Preliminary Information

PIT5666B Squeak/Creak/Squawk/Itch Type Noise Heard From The I/P or Center Console Area

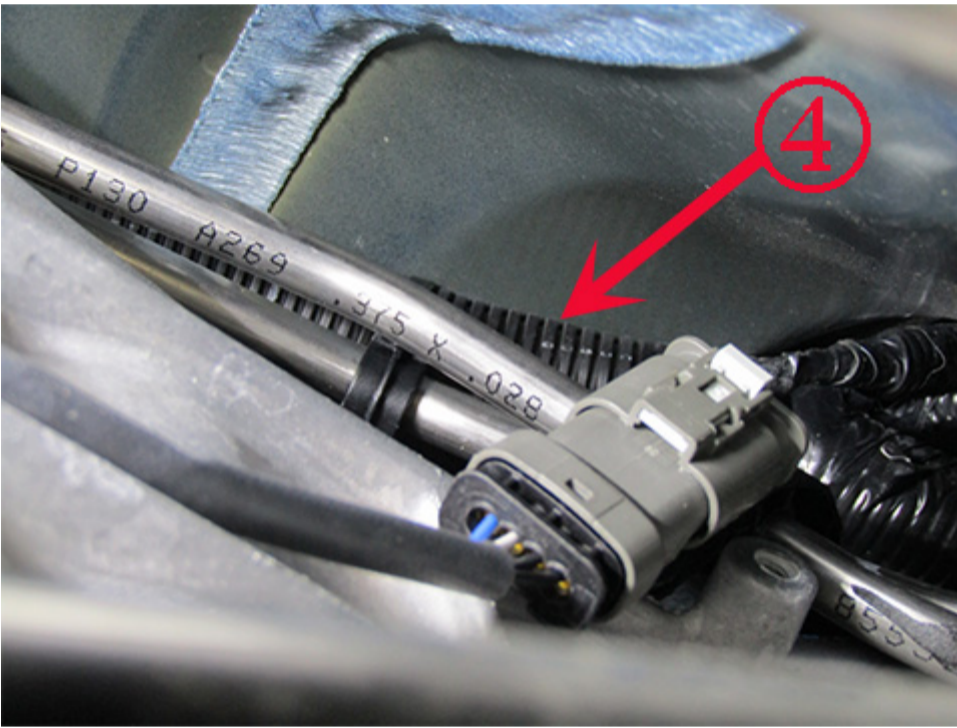
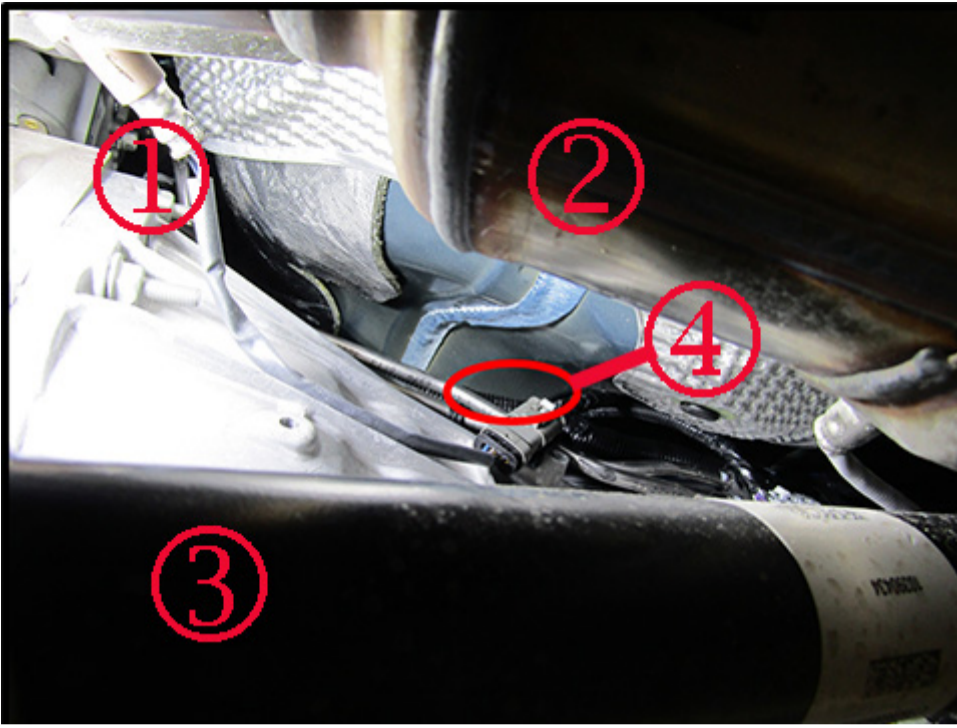
Involved Region or Country	North America
Condition	<p>Note: The Labor Code in this PI should not be used if it wasn't the root cause of the customer's complaint.</p> <p>Some customers may comment of a squeak, creak, itch, or rubber type noise heard from the IP dash or center console area. The noise may be duplicated by the following:</p> <ul style="list-style-type: none"> - Driving over bumps (noise may go away if coasting or if transmission is shifted into "N") - During acceleration - Brake torqueing in drive (noise may not occur when brake torqueing in reverse)
Cause	<p>This noise could be caused by the engine harness rubbing on the floor pan above the transmission (item numbers 4 and 5), as shown below. The photos below were taken from under the vehicle looking up along the driver's side of the transmission bell housing.</p> <p>Callout 1 - Bank 1 Sensor 1 O2 sensor Callout 2 - Bank 1 Catalytic Converter Callout 3 - Front Driveshaft (on 4WD vehicles) Callout 4 - Engine Harness rubbing on floor pan Callout 5 - Engine Harness pushed aside to show the contact on the floor pan</p>

Reposition and secure the engine harness down beside the fuel/evap lines so it no longer contacts the floor pan, as shown below. The rear transmission crossmember may need to be removed so that the transmission can be slightly lowered to gain access to the area. To allow enough slack in the engine harness to reposition it down

beside the fuel/evap lines, it needs to be moved/repositioned forward in the clips at the rear of the harness above the rear of the transmission/transfer case. First, release the rear harness clips and move/reposition the harness forward in the clips, then lock the clips closed. This will create enough slack in the harness to reposition and secure the harness down beside the fuel/evap lines, as shown below.
